Groundwater Transfer Review Summary Form

Transfer/PA # T- 14278

Application: T-14278

Applicant Name: T and K Sester Family, LLC

Thisis Drawdown Analysis – Authorized POA MULT 2519 to CLAC 57578

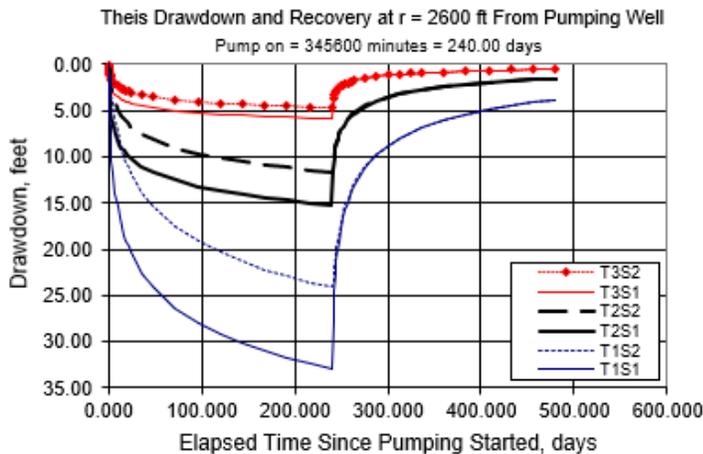
Yes No If yes, explain: To evaluate the potential additional interference with CLAC 57578, a Theis (1935) drawdown analysis was completed. Aquifer parameters used for the analysis were derived from regional data and studies (Pumping Test Reports for MULT 2533, MULT 3476; McFarland and Morgan, 1996; Swanson et al., 1993).

To provide a conservative analysis, it was assumed that authorized POA MULT 2519 would be pumped non-stop at the maximum authorized rate under certificate 60741 (0.40 cfs, ~180 gpm) up to the associated duty, which would effectively be limited by the 240-day irrigation period. Pumping at proposed APOA MULT 67819 was also simulated at 0.40 cfs (while MULT 67819 is also authorized for an additional combined rate of 1.35 cfs, the pumping test rate stated on its well log is only ~0.36 cfs with 110 feet of drawdown; with recent static water levels in MULT 67819 on the order of ~350-385 ft bls, it appears that even less than 110 feet of drawdown is available in this well, which supports using the lower 0.40 cfs rate for this analysis).

Results of the Theis comparative analysis indicate that additional interference with CLAC 57578 could range from about 5 to 15 feet based on these conservative pumping scenarios. Using the 2024 static water level measurement reported for CLAC 57578 of approximately 245 ft bls, there is approximately 250 feet of available drawdown in CLAC 57578. This amount should allow both the current authorized use of CLAC 57578 (i.e., at its current drawdown or pumping water level) plus the range of additional interference drawdown predicted for this proposed use; thus, it is not likely that the proposed use will result in CLAC 57578 or another similar groundwater right from receiving the water to which it is legally entitled.
